Device **XC878LM Series**
Marking/Step **AC**
Package **PG-LQFP-64**

This Errata Sheet describes the deviations from the current user documentation. The module oriented classification and numbering system uses an ascending sequence over several derivatives, including already solved deviations. So gaps inside this enumeration can occur.

This Errata Sheet covers the following devices:

- XC878-13/16FF
- XC878M-13/16FF
- XC878LM-13/16FF

Figure 1 Counting sequence of T12 in center-aligned mode

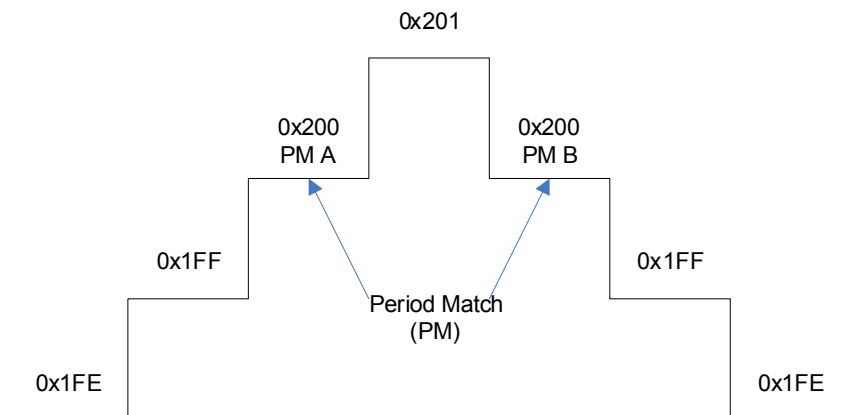
CCU6_XC8.H002 CCU6 PM event in center-aligned mode

After detecting a period match (PM A) in centre-aligned mode, T12 counts down from PM + 1 as shown below:

This means a second PM event (PM B) will occur during the counting down. If ADC is triggered externally via ETRx2 (T12PM), it will be triggered twice in succession. Depending on how real-time the application code is running as well

as the T12 count rate and ADC conversion rate, the application could observe two ADC interrupts - once at PM A and once at PM B.

To avoid triggering twice the ADC interrupts, it is suggested to use ETRx6 from multi-channel mode instead of ETRx2 as the trigger source for ADC. Additional initialization are as follows:

- Configure MCMCTR.SWSEL = 101_B (Transfer on T12 period match)
- Configure MCMCTR.SWSYN = 00_B (Direct transfer)
- Write to MCMOUTSTL = CF_H (To enable multi-Channel PWM pattern on CC6x and COUT6x)

Note: Independent of the external trigger, the CCU6 internal triggers based on T12 PM (e.g. T12 PM interrupt or shadow transfer) are only activated once while T12 is counting up.

Figure 2 Noise Immunity Enhancement Circuitry

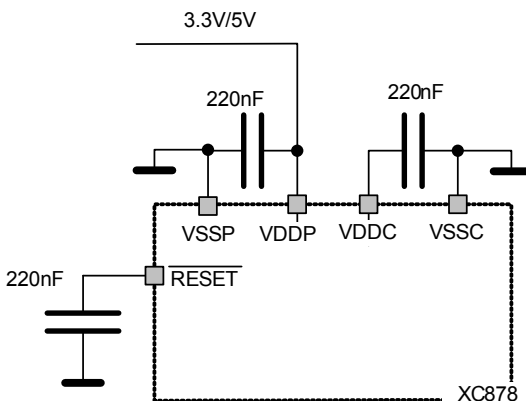
EVR_XC8.H002 Enhancement for Noise Immunity

During power up, the EVR functionality may be affected due to injected noise from any functional pin. In order to enhance the noise immunity, the external reset pin RESET must be asserted until VDDC reaches $0.9 * VDDC$. The delay of external reset can be realized by an external capacitor at RESET pin. This capacitor value must be selected so that VRESET reaches 0.4 V, but not before VDDC reaches $0.9 * VDDC$.

A typical application example is shown in **Figure 2**. A 220 nF capacitor is connected to VDDP pin, VDDC pin and RESET pin. In addition, it is also essential to put it as close as possible to the chip.
